VIRGINIA ELECTRIC AND POWER COMPANY
RICHMOND, VIRGINIA 23261

VIRGINIA ELECTRIC AND POWER COMPANY
SURRY POWER STATION UNITS 1 AND 2
PROPOSED LICENSE AMENDMENT REQUEST
REMOVAL OF REFUELING WATER CHEMICAL ADDITION TANK AND
REPLACEMENT OF CONTAINMENT SUMP BUFFER

**CONTAINMENT SPRAY SYSTEM SHOWING CURRENT
AND MODIFIED CONFIGURATIONS**

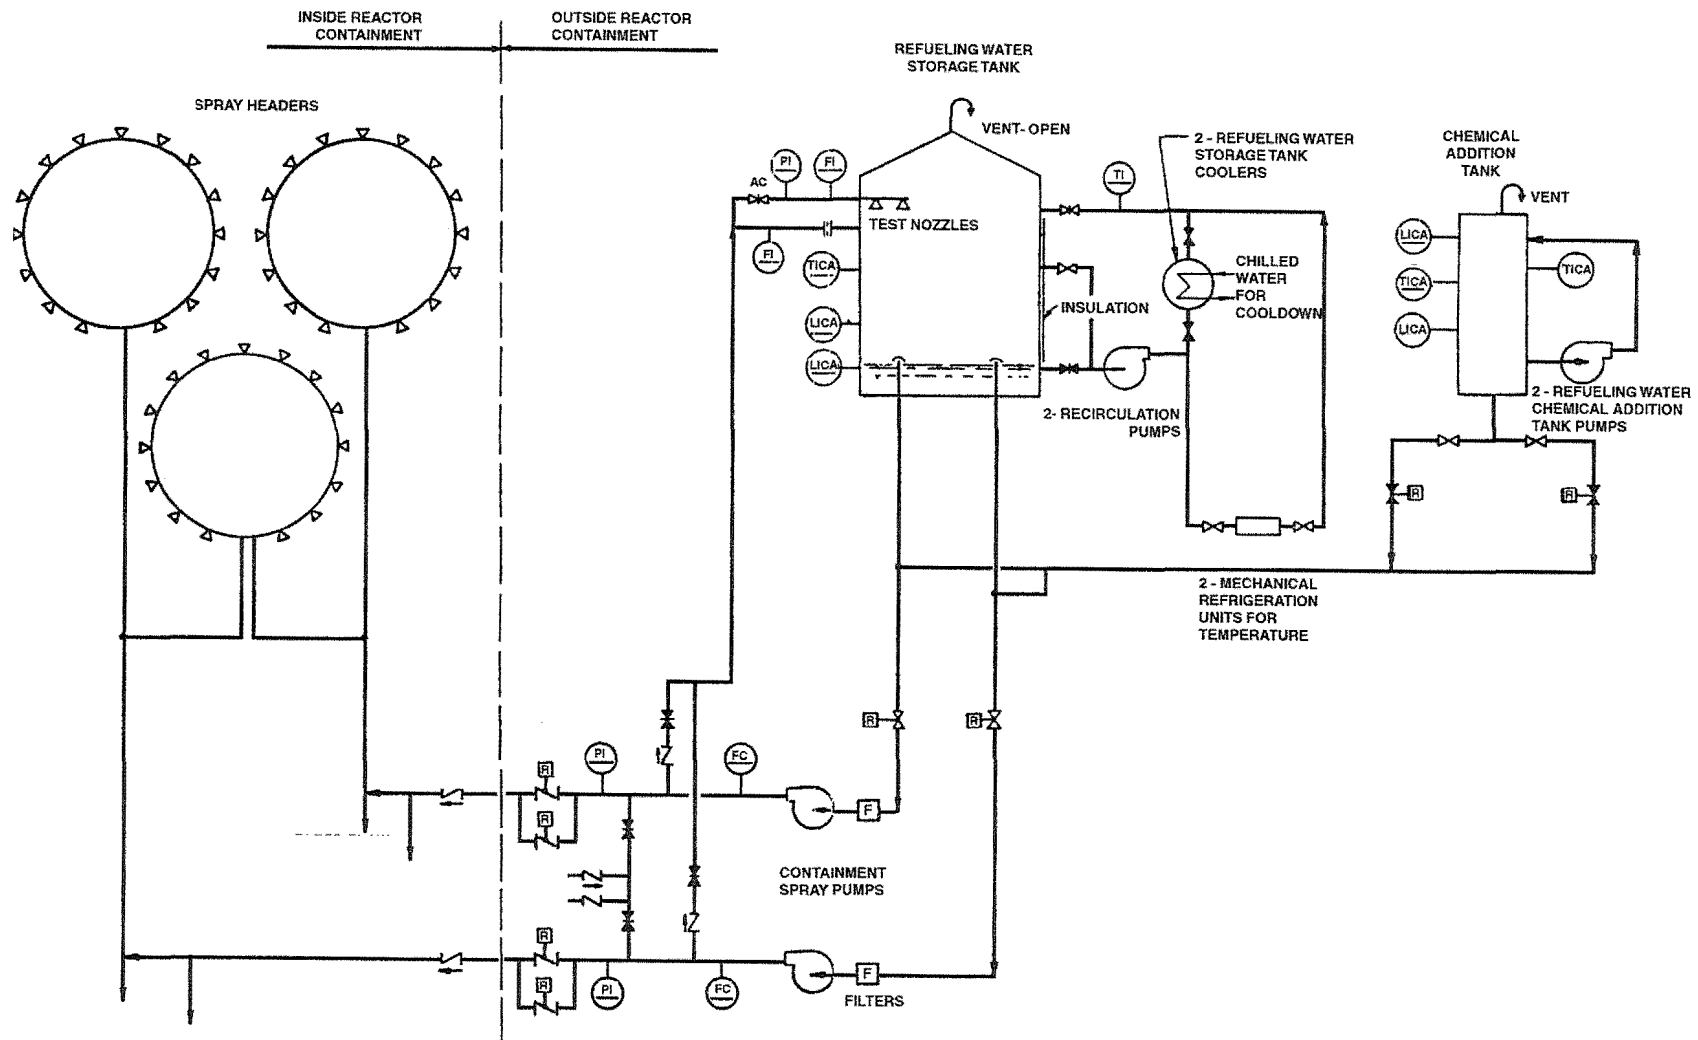
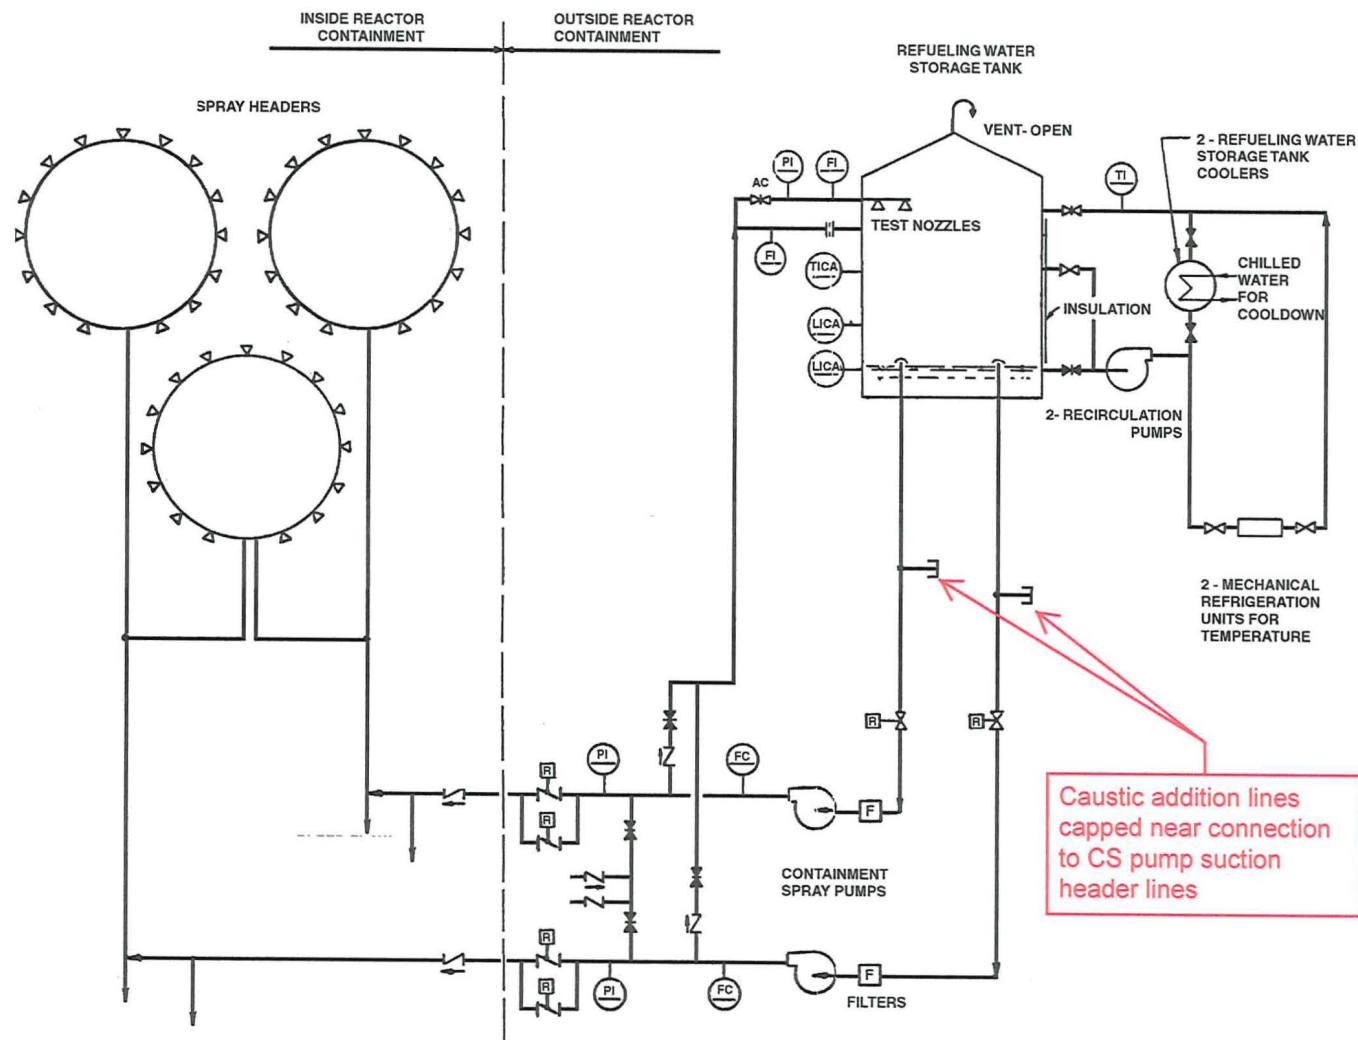
The proposed change replaces the NaOH in the CAT with granular NaTB in baskets located in the containment. The NaOH is mixed with RWST water during the CS system spray down of containment prior to entering containment. The replacement NaTB baskets will be placed in the lower level / basement (EL. -27'-7") of the containment. Thus, mixing with RWST water will not occur until after the initial spray of containment and when the RWST water collects in the lower levels of the containment. Both buffering agents, NaOH and NaTB, are considered acceptable buffering agents to raise the pH levels of the RWST water and remove iodine from containment. The CAT and associated caustic piping and equipment will be permanently isolated from the CS system and removed.

The CAT (01(02)-CS-TK-2) will be isolated from the CS system and drained. The CAT, caustic addition piping and associated equipment will be removed permanently up to the connection with the CS pump suction header lines, with the exception of the portions of the buried pipe. The portions of the associated piping that remain in place will be capped. Attachment 2 shows the current configuration of the CS system and the proposed change to permanently isolate and remove the CAT and associated piping and equipment. The proposed change will not alter the seismic classification of the remaining CS system (Seismic Class I). The associated instrumentation, indications and controls will be disconnected and removed.

CONTAINMENT SPRAY SYSTEM - CURRENT CONFIGURATION

CONTAINMENT SPRAY SYSTEM - MODIFIED CONFIGURATION
